SUBJECT: SAFETY RECALL OF CARRIER DEFROSTER SPEED CONTROLLERS

Ref.: **NHTSA # 06V-241**
TRANSPORT CANADA # 06-173
MCI Service Bulletins 258B and 271B

Service Bulletin No. 258B

MODEL	TYPE	SECTION/GROUP	DATE
E / J Series Coaches	Field Change Program	16--HVAC	Aug. 14, 2006
SUBJECT			
CARRIER DEFROSTER SPEED CONTROLLERS			
CONDITIONS

Figure 1.

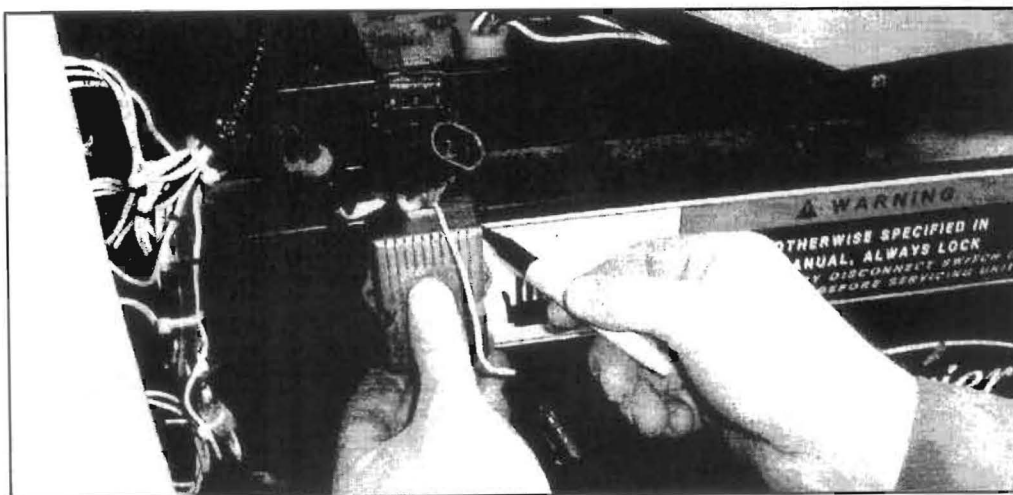
1. Turn the main battery disconnect switch to the OFF position.
2. Remove the stepwell panel and place aside to be re-installed at a later step in this procedure.
3. Position the motor drive module (p/n 07-08-1860) on the access panel in the location shown in Figure 1.
Using the side edge of the motor drive module, trace the outline with a marker.

Figure 2.

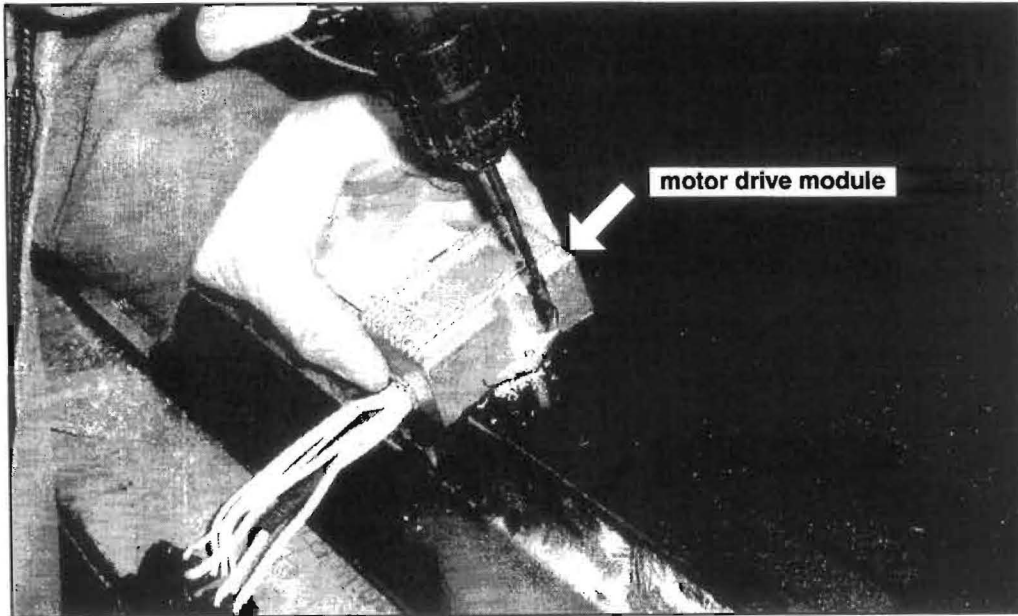
4. Remove the access panel and place on a workbench. Align the motor drive module with the outline mark made in Step 3. Using a 11/64 inch drill bit, drill pilot holes in the access panel using the motor drive module holes as a template (Figure 2). Using a 13/64 inch drill bit, re-drill the holes.
5. Using the screw (p/n 19-1-609) and nut (p/n 19-11-223) in the Parts list, mount the motor drive module to the access panel with the pan head of the screw orientated to the interior of the panel (Figure 3).

Figure 3.

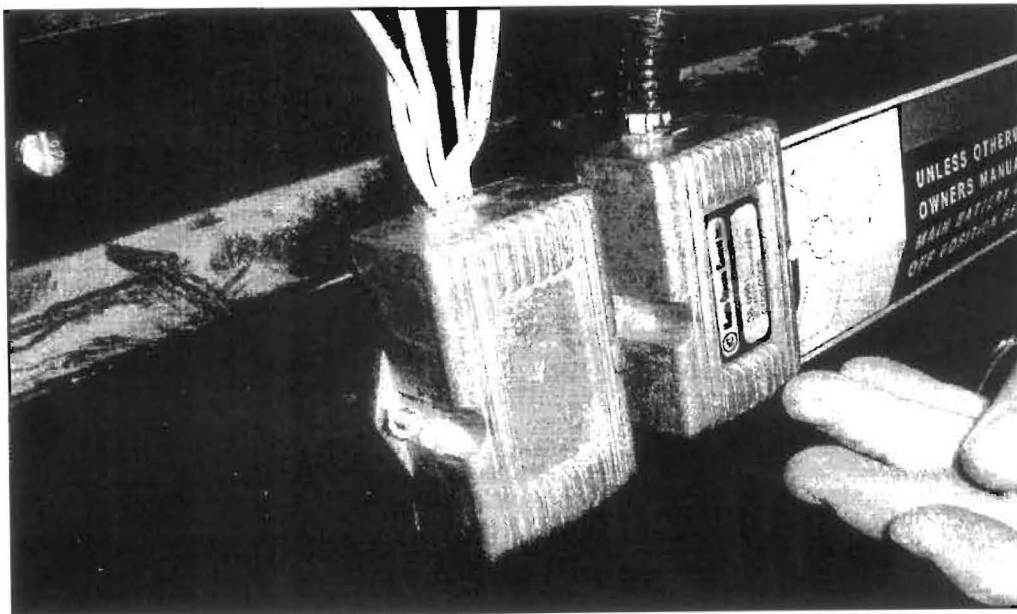
6. Repeat Steps 4. and 5. for the second motor drive module (Figure 3).

Figure 4.

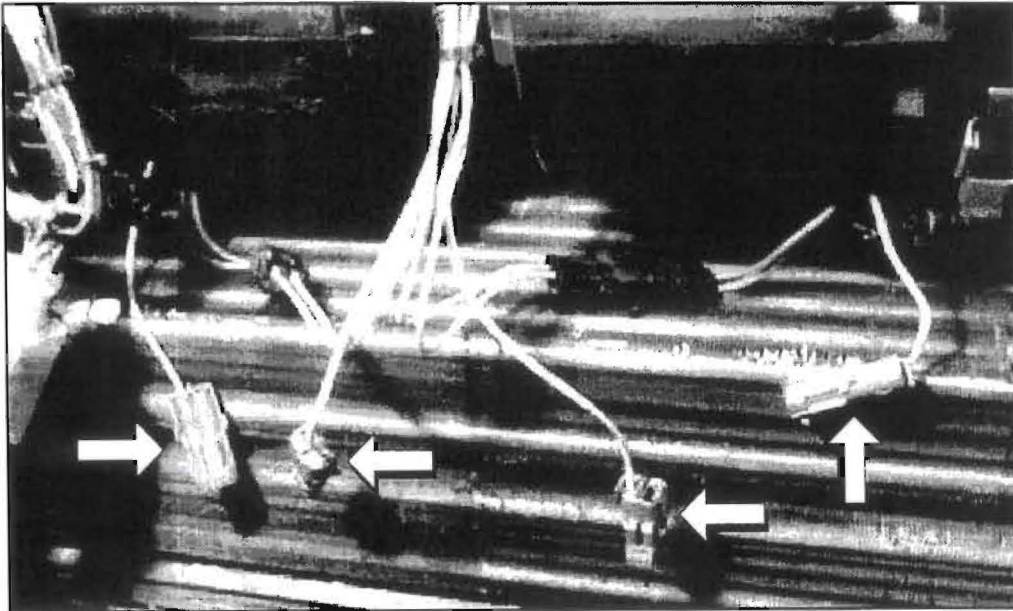
7. Disconnect the three connectors leading to each of the existing control modules. Drill out the two rivets holding the existing modules in place. Remove and retain the existing modules, **as they are required to be returned to MCI**. Connect the two wire receptacles from the coach harness directly to the motor plugs (Figure 4).
8. Using tyrapas (p/n 19-11-258), tie back the single wire plugs on the disconnected coach harnesses.

Figure 5.

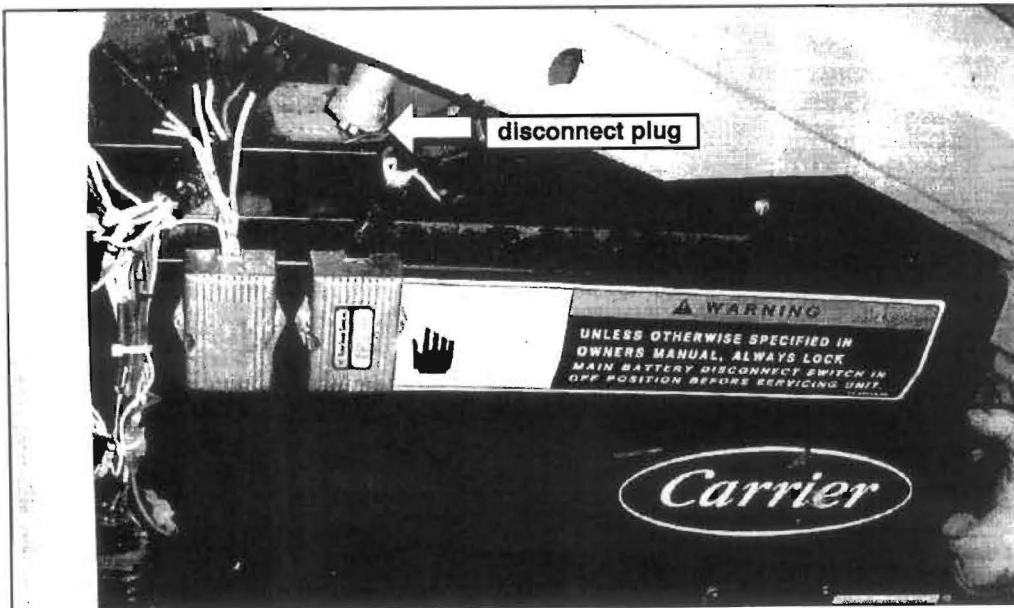
9. Disconnect the round 5-pin Deutsch plug (Figure 5) (if applicable).
10. Align and re-install the access panel (Figure 5).

Figure 6. Instrument panel with upper, rubber cover removed.

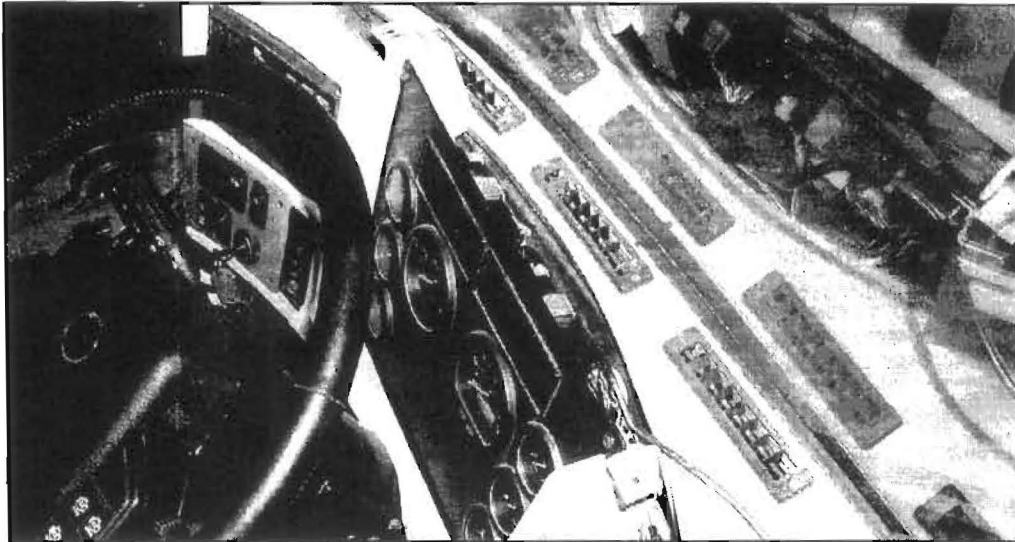
11. Remove the upper, rubber cover from the top of the instrument panel.

Figure 7. Plug (p/n 19-11-1403).

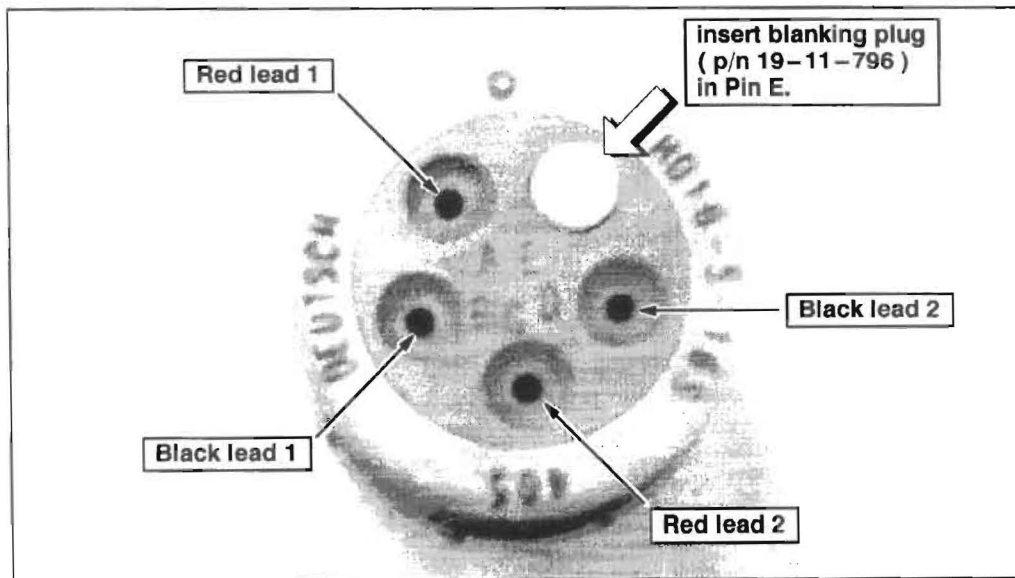
12. Using an 5/64 inch Allen key, remove the upper, LH dash panel from the instrument panel.
13. Route the driver evaporator harness (part number 07-12-1915) from the upper, LH dash panel area to the stepwell area, behind the instrument panel.
14. On a workbench, insert the blanking plug (p/n 19-11-796) into Pin E of the 5-pin Deutsch connector plug (part number 19-11-1403). Load the open red and black leads from the appropriate motor drive module into the 5-pin Deutsch connector plug, in the locations shown in Figure 7.

If the coach is not equipped with round 5-pin Deutsch plug (refer to Step 9.), connectors 19-11-1356 and 19-11-1358 have to be utilized, replacing the 5-pin Deutsch connector plug (part number 19-11-1403). When loading the open red and black leads, locations A, B, C, D, E will be replaced with locations 1, 2, 3, 4 and 5.

Figure 8.

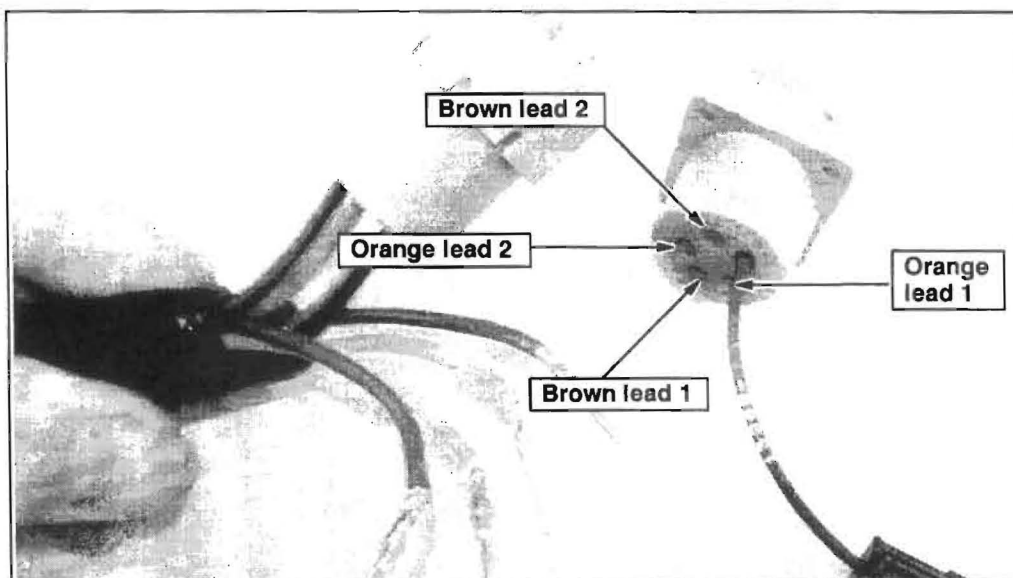
15. Load the open orange and brown leads into the driver evaporator harness connector, as shown in Figure 8.

Figure 9.

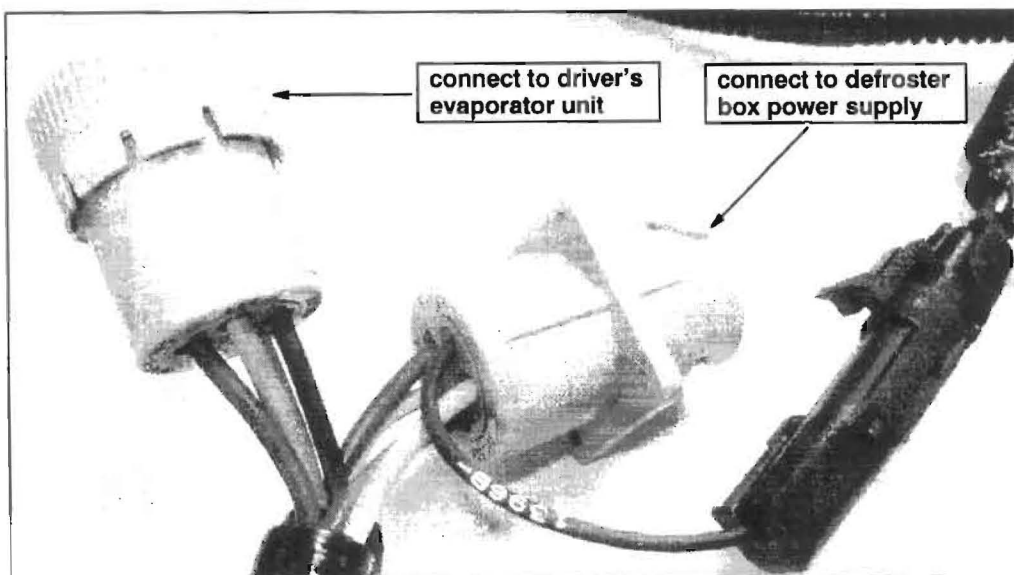
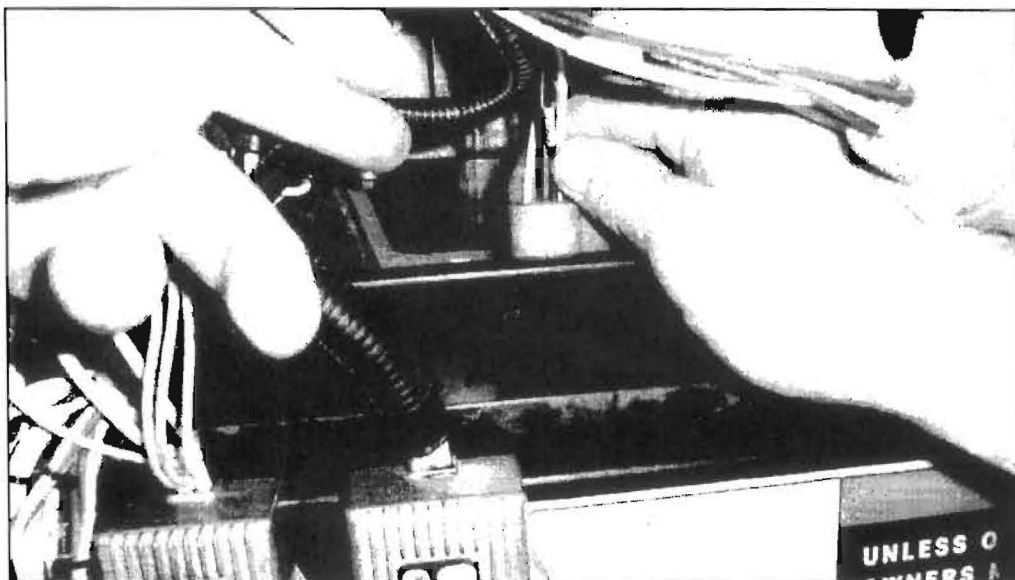
16. Connect the 5-pin Deutsch connector plug to the driver's evaporator unit (Figures 9 and 10). Connect the driver evaporator harness connector to the defroster box power supply (Figure 9).

Figure 11.

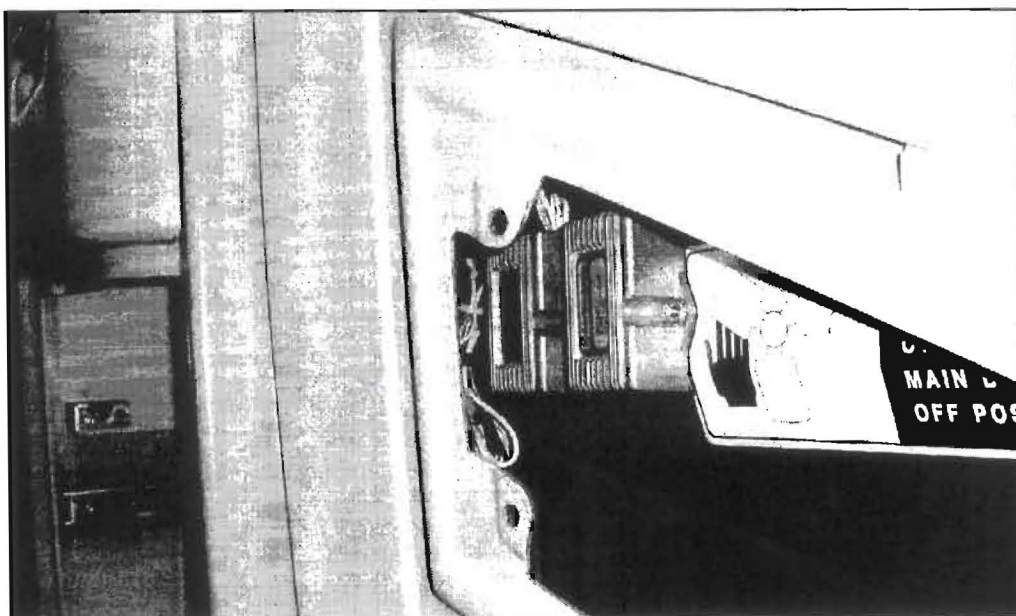
17. Using tyrap (part number 19-11-258), bundle the harnesses and wires (Figure 11).

Access to the top, roadside mounting stud for the stepwell panel will be blocked by the new motor drive module installation. Access can be gained through the driver's drawer (Figure 11).

Figure 12.

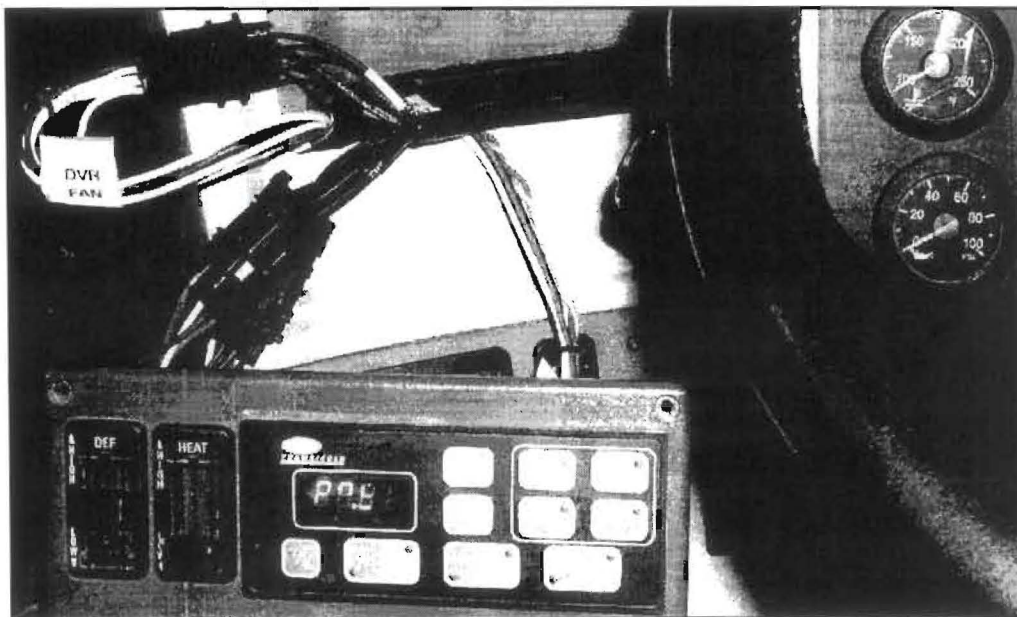
19. Disconnect the defrost slide switch harness from the dash harness. Connect the harness (p/n 07-12-1915) to the defrost slide switch harness and the dash harness (Figure 12).

Figure 13. Schematic.

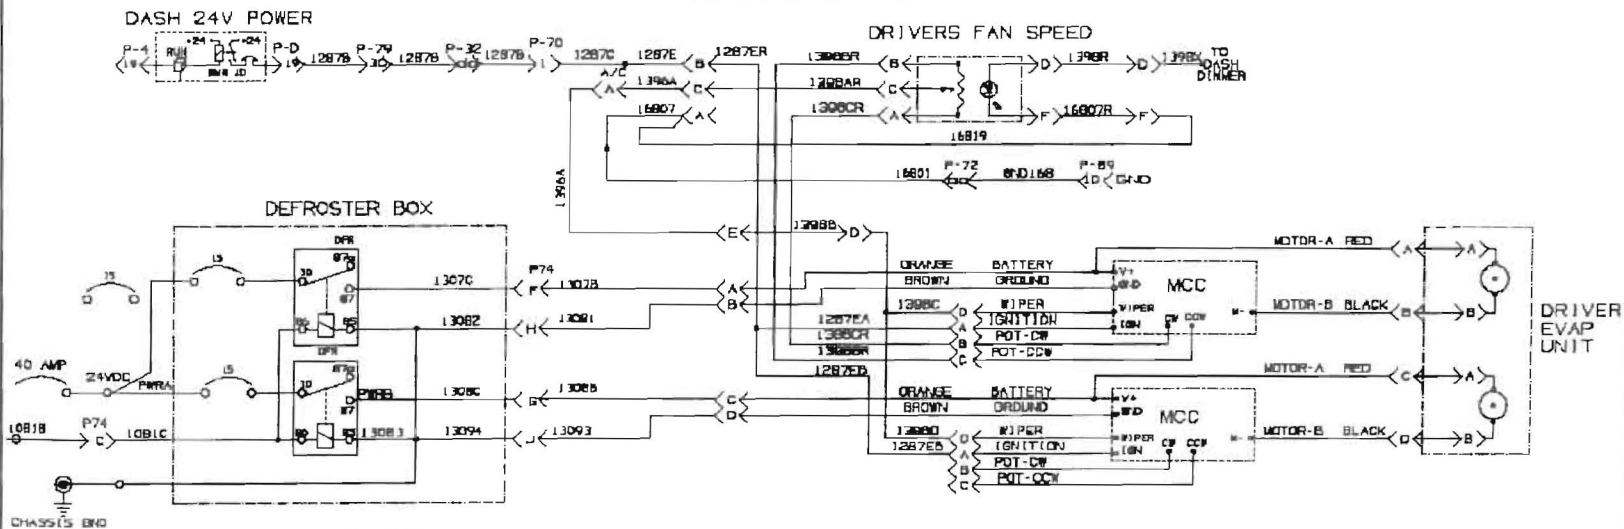
20. Connect the 4-pin weatherpacks of the driver evaporator harness to the 4-pin weatherpacks on the motor drive modules.

NEW SET-UP
